RECEIPT DATE: 4-3-23 **ONSITE SEWAGE DISPOSAL SYSTEM** P 574072
 APPROVAL DATE: _____ **PERMIT: CONSTRUCTION** A _____
 PROPERTY ADDRESS: 12363 Pleasant View Drive
 SUBDIVISION: Fulton Manor LOT: 27 TAX ID: 5418178
 CONTRACTOR: Hofffields Equipment EMAIL: Ken@hofffieldsequipment.com
 CONTRACTOR ADDRESS: P.O. Box 519 Annapolis Junction MD 20701 PHONE: 301-490-4289
 PROPERTY OWNER: John Sessler EMAIL: _____
 OWNER ADDRESS: 12363 Pleasant View Drive PHONE: 410-980-9868

LOT 27, FULTON MANOR
ON-SITE SEWAGE DISPOSAL SYSTEM PLAN
12363 PLEASANT VIEW DRIVE
FULTON, MD 21029
TAX#: 418178, SUB: 2204

From: Silvast, Zackary <zsilvast@howardcountymd.gov>
Sent: Thursday, September 8, 2022 6:26 PM
To: Brian Collins <Brian.Collins@kci.com>
Cc: Martin, Sharhonda <smmartin@howardcountymd.gov>
Subject: Regarding 12363 Pleasant View Drive (PC & OSDS plans)

LOT 27, FULTON MANOR
ON-SITE SEWERAGE DISPOSAL SYSTEM PLAN
12363 PLEASANT VIEW DRIVE
FULTON, MD 21029
TAG#: 418178, SUB: 2204

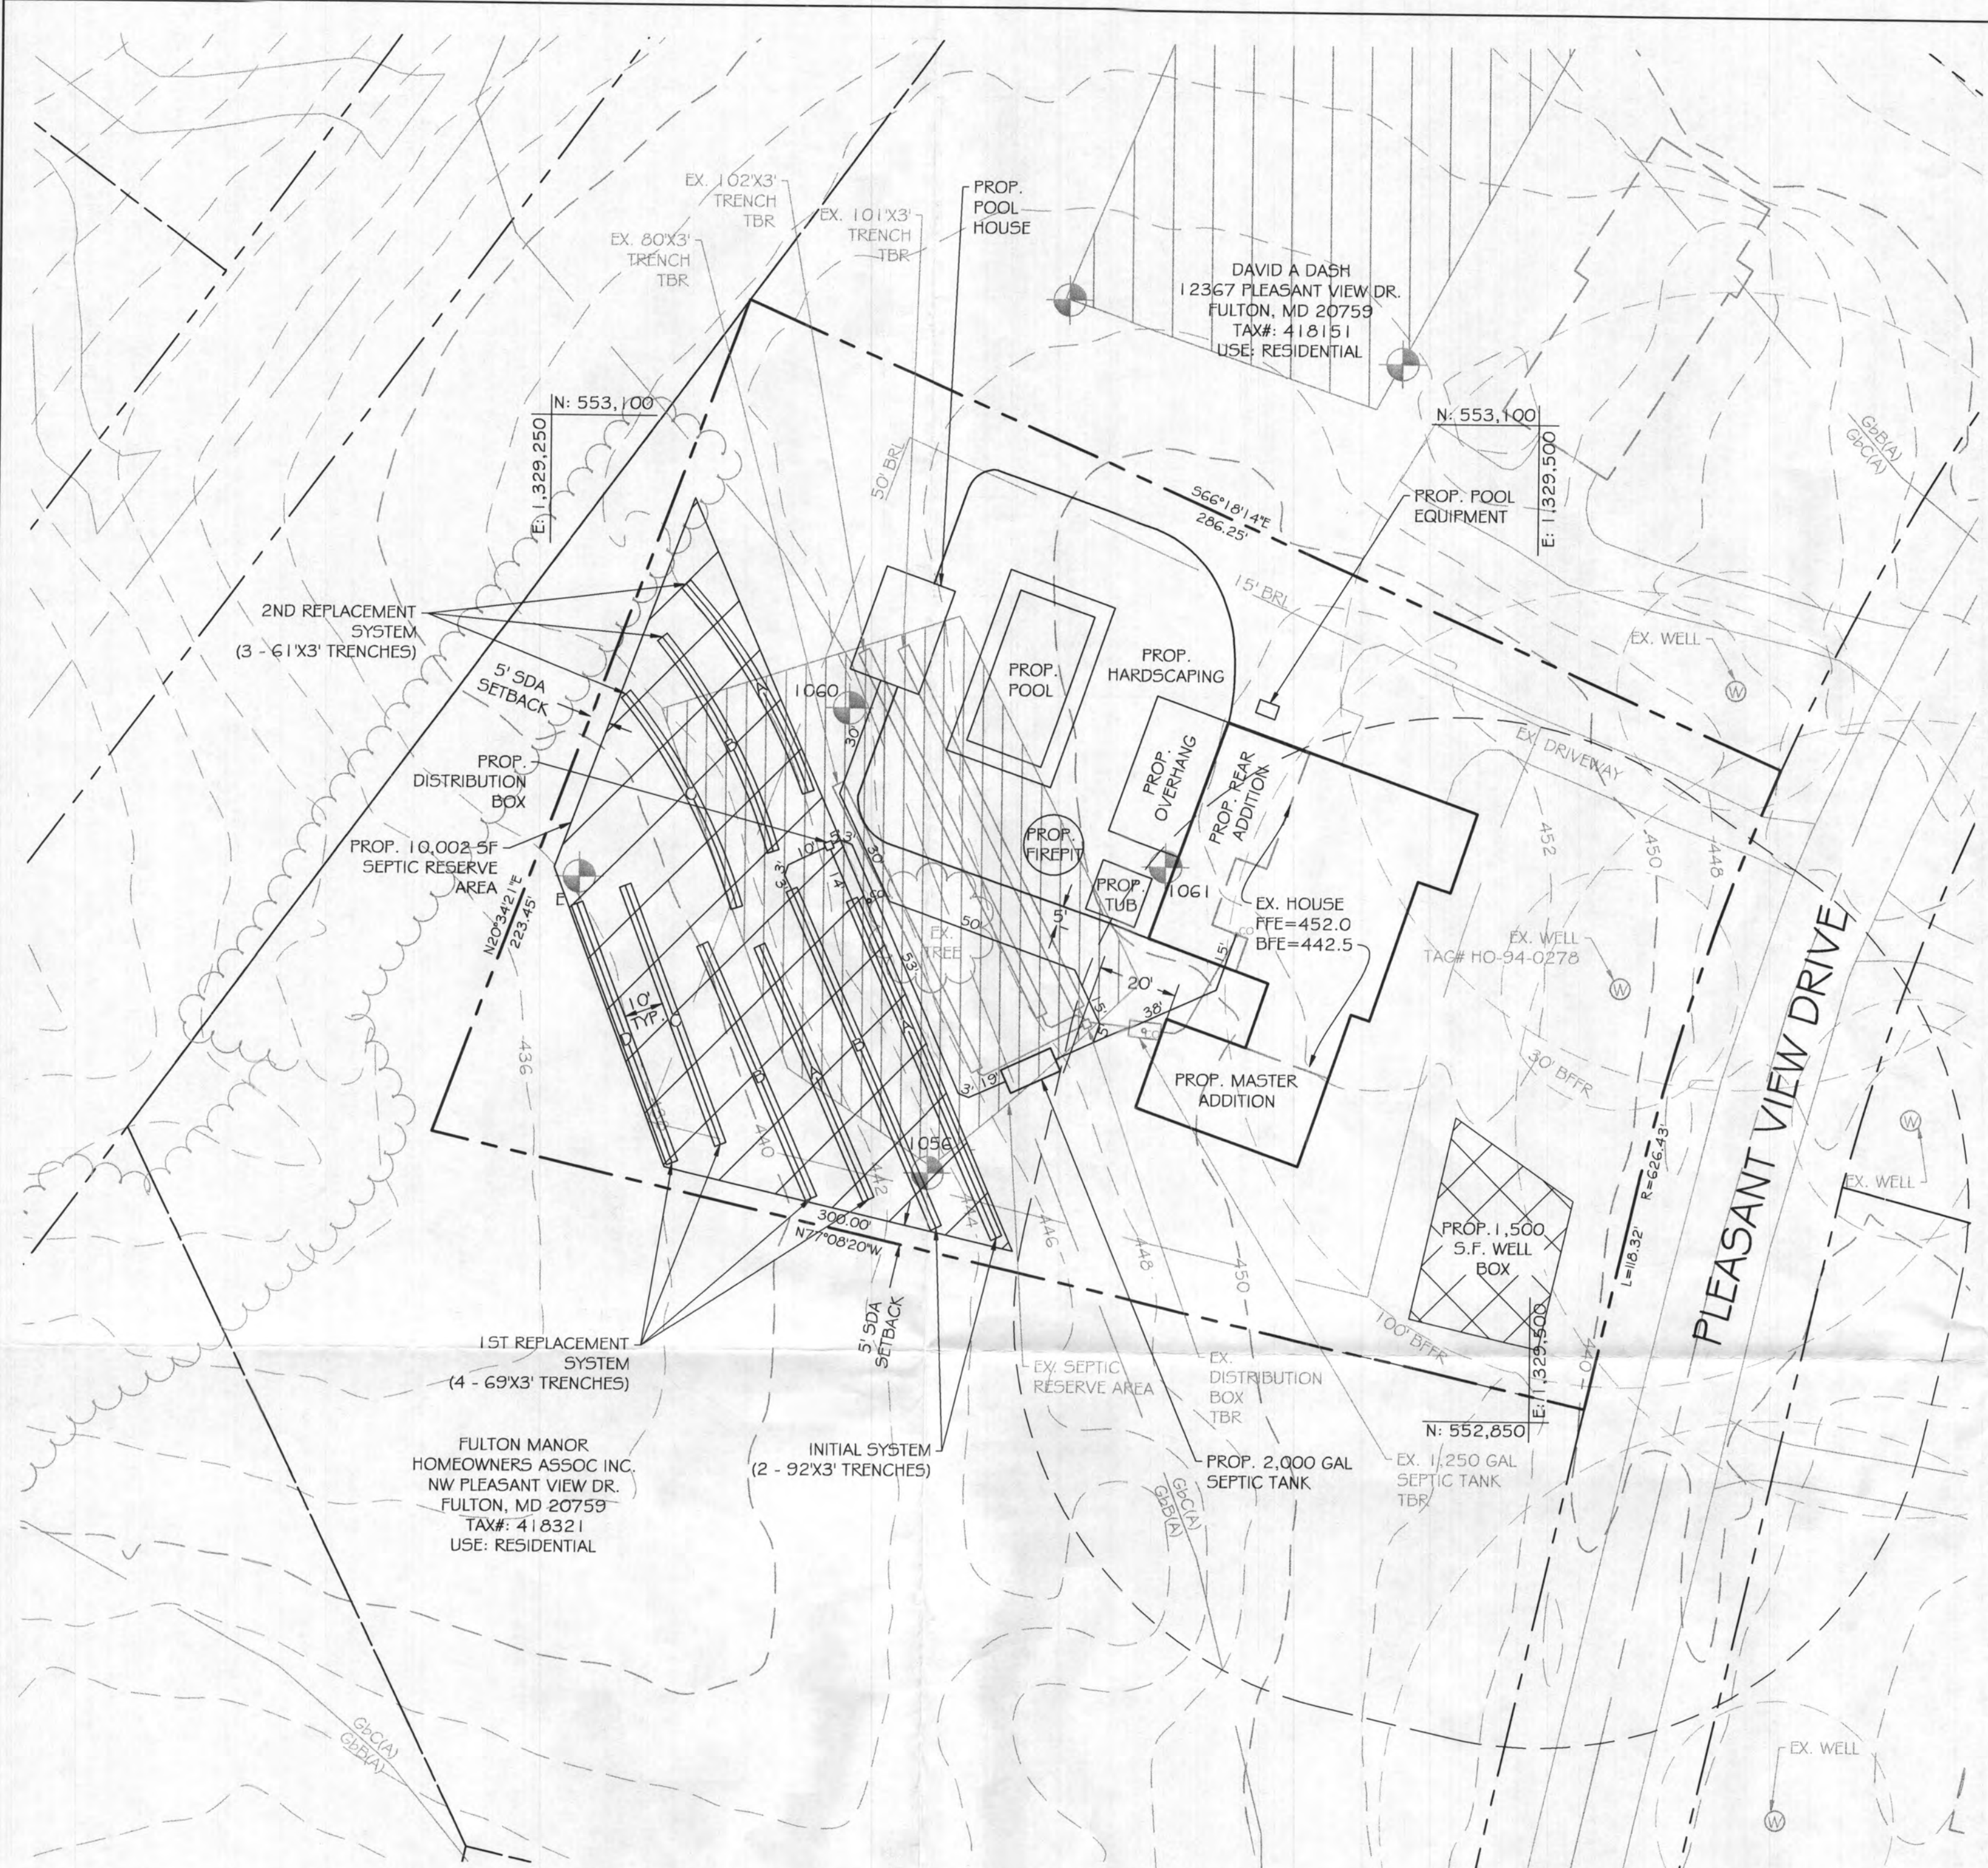
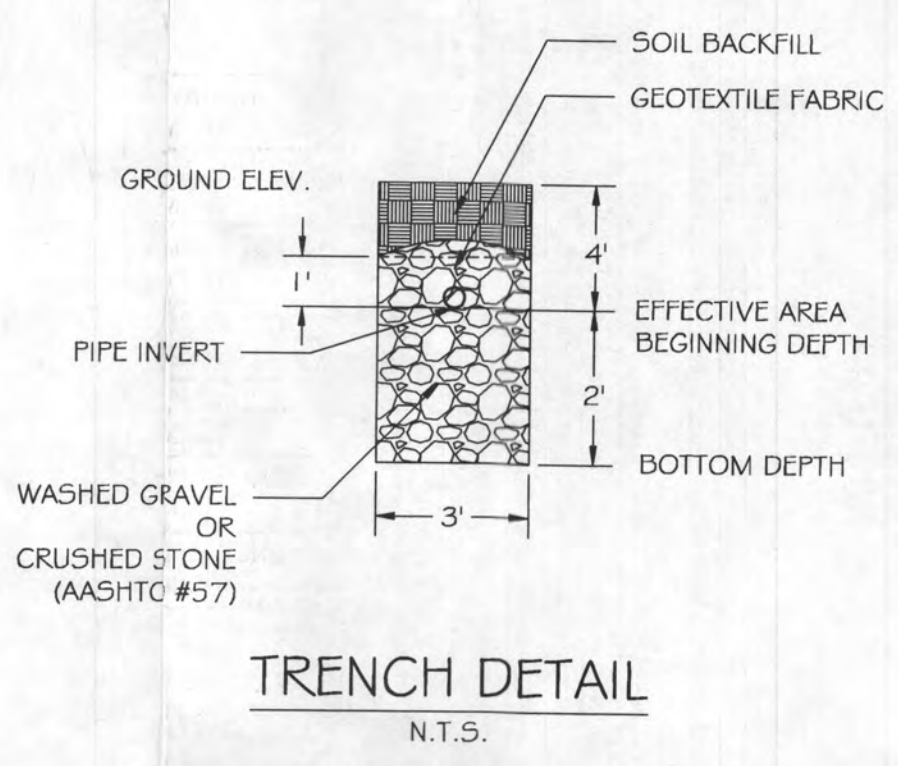
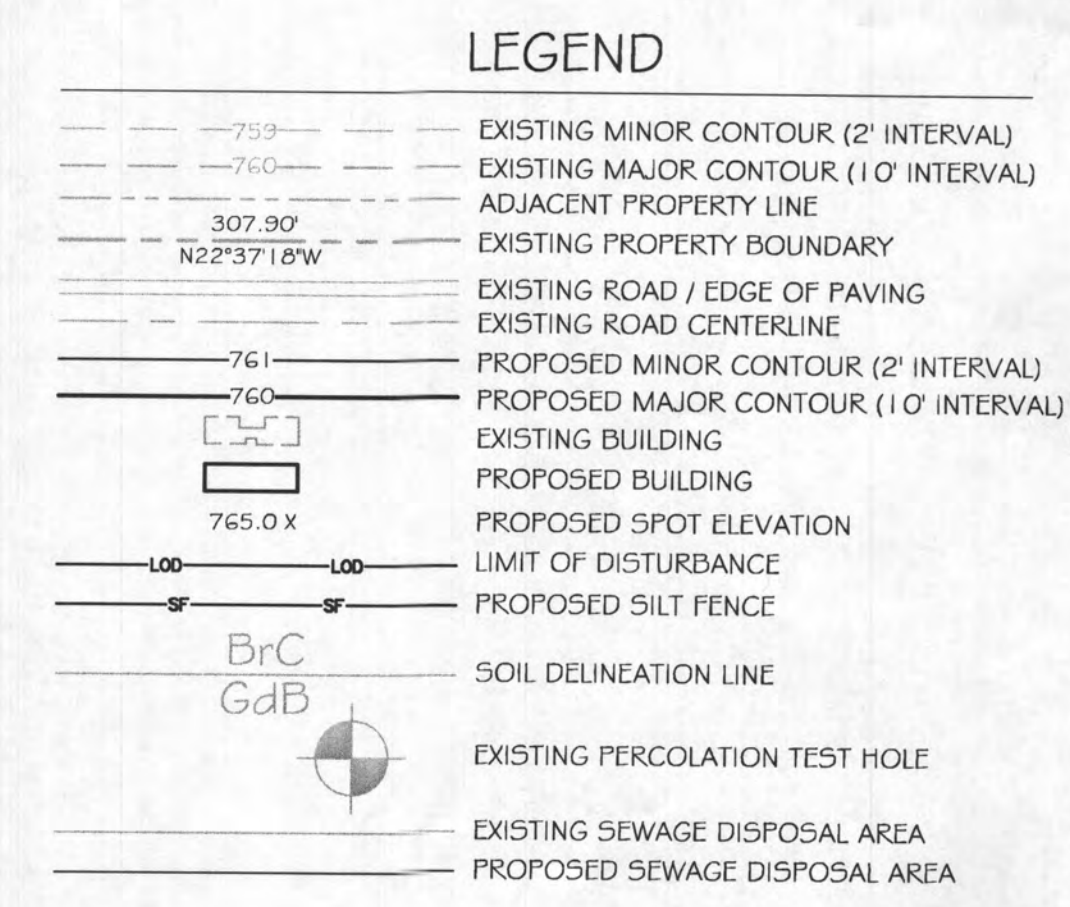
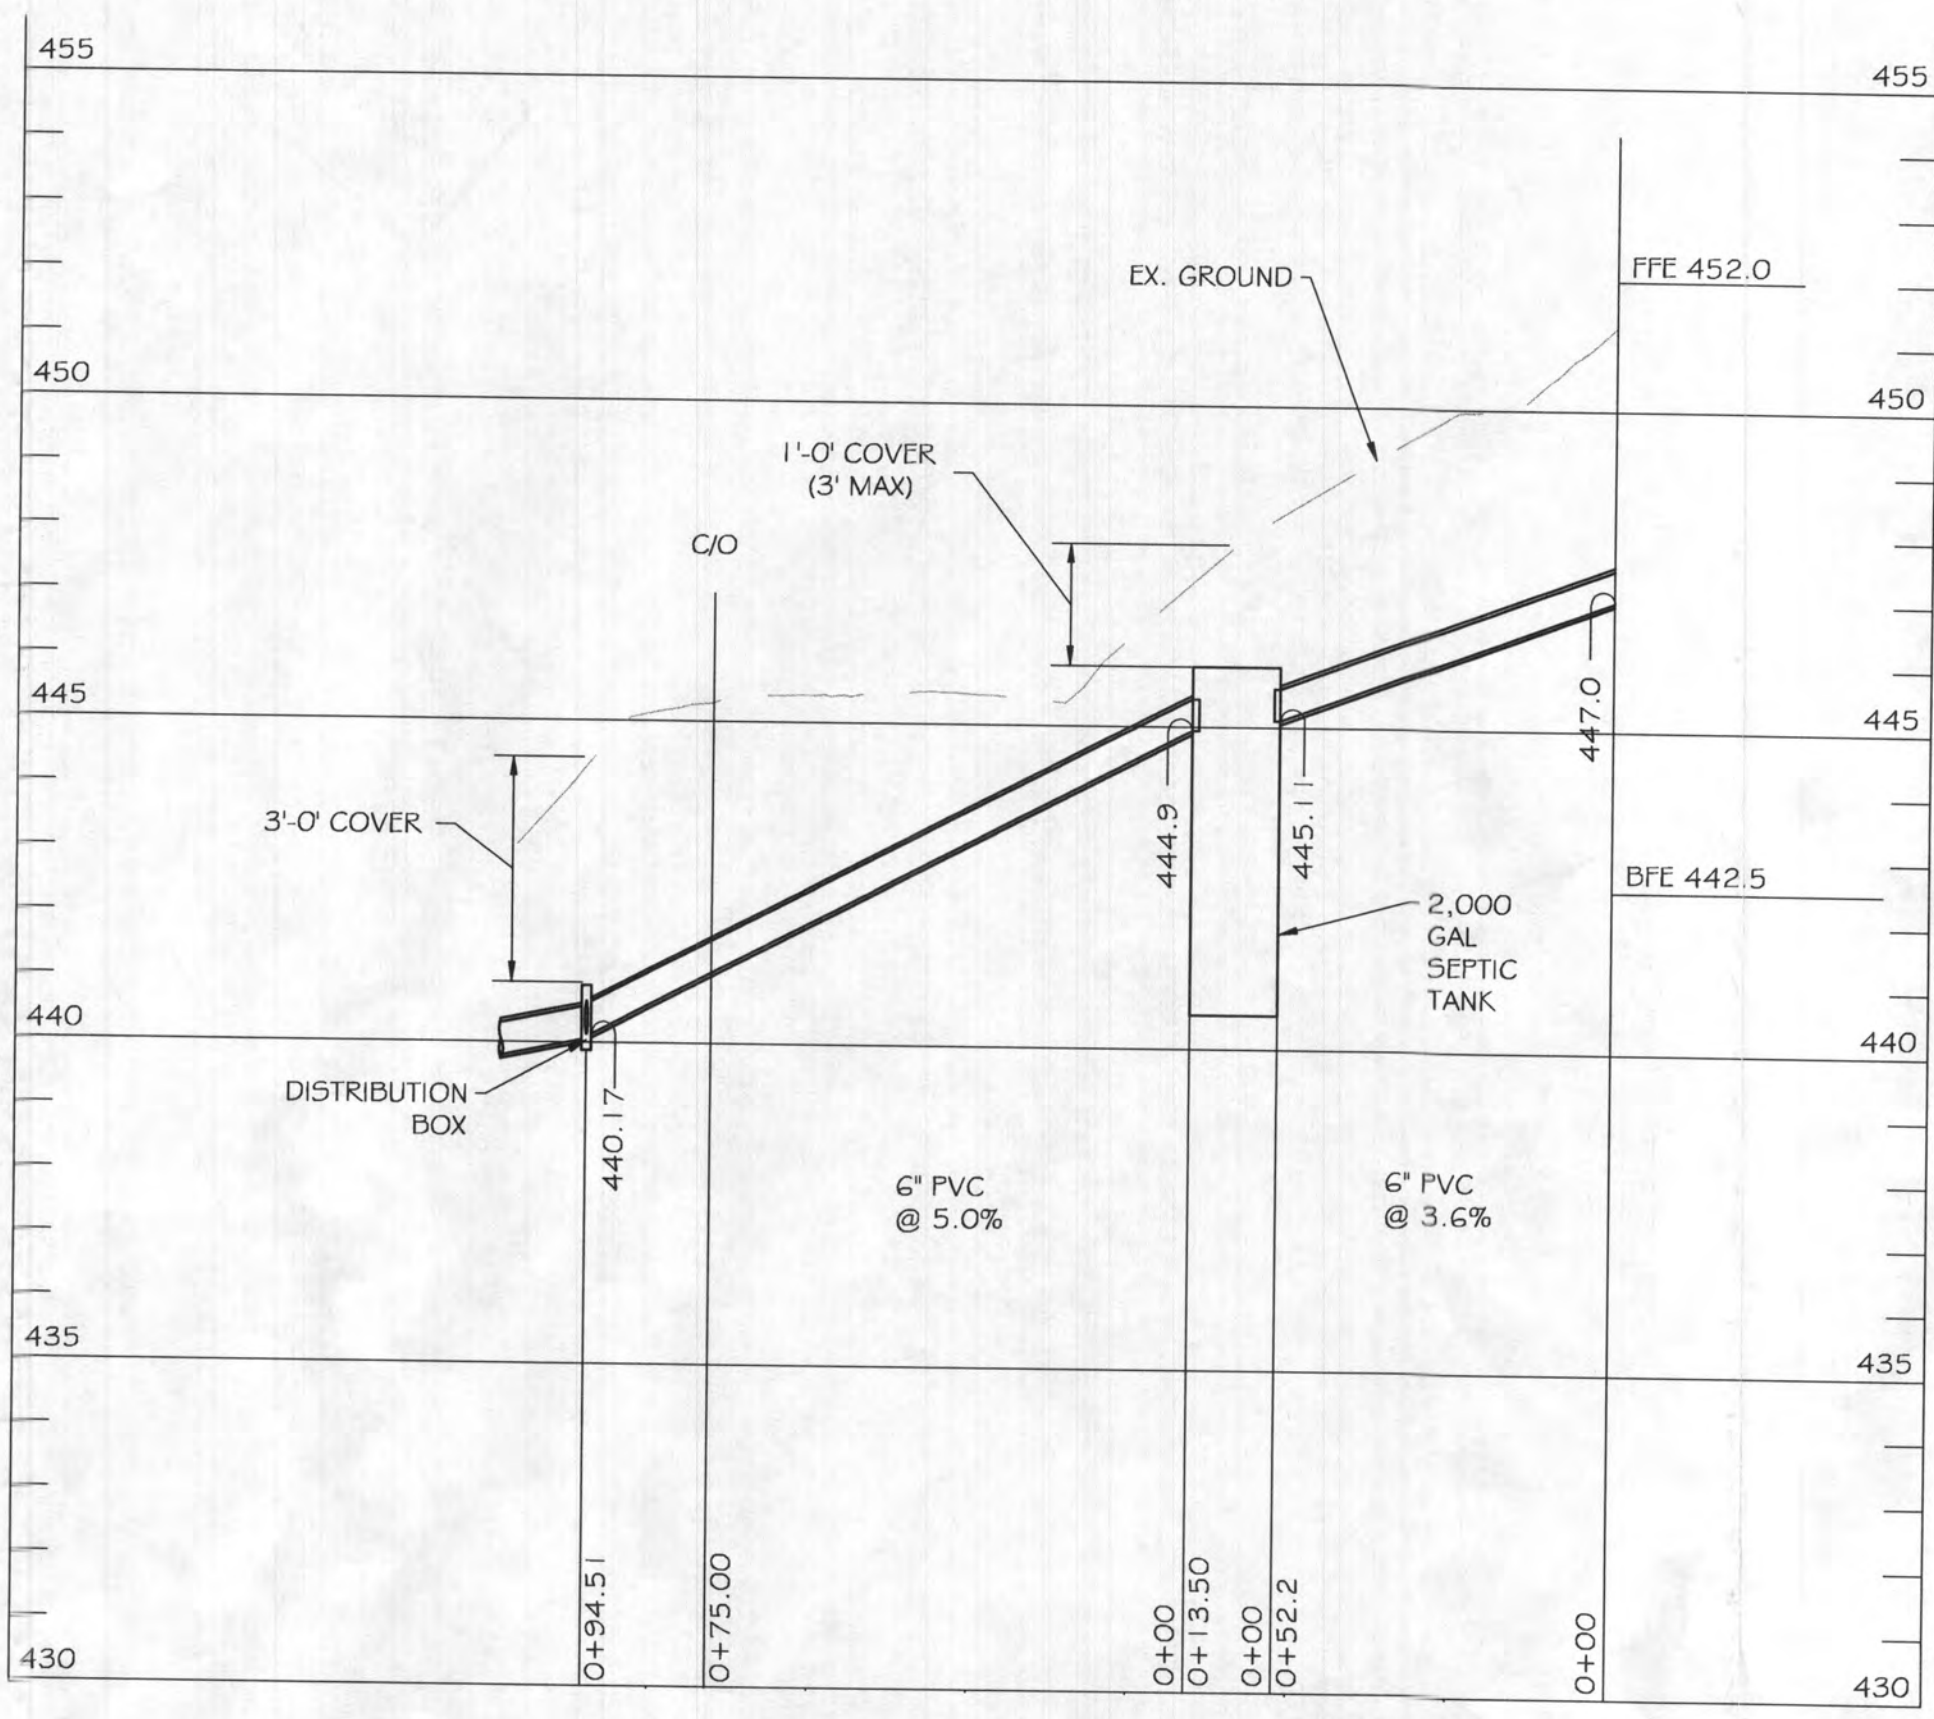
1. I let it go on the perc cert. to speed up the process and since the perc cert. had already gained approval back in April as is, but the wells should have been shown with the well tag numbers on them also.

- a. It would have been appropriate to include those tag numbers and with a lighter font than the subject property.
 - b. I do want the tag numbers included on the OSDS plan.

2. The 1st replacement system should have been designed with 1' effective depth.
 - A. I have attached Bricker's original spec sheet (see attached above).

- B. This may change some of the configuration as that 1st replacement system will now be even larger.
 - a. It is important to note that the lines should stay as linear as possible and on contour as much as possible.

- b. No crazy configurations to squeeze everything in. (not saying you would, but as a point to be made)
3. I am confused by note number 11. I think all three of these systems would be able to achieve gravity distribution.

- A. If one system needs to be an LPD, those details need to be provided on the OSDS even if it is for a "future repair."
 - B. Now would be the time to do that LPD design.

- C. You would also want to include "the future pump pit location." And show both of those "tank details."
 - a. Pump tank should be lighter and dotted on the site plan since it is for future use.
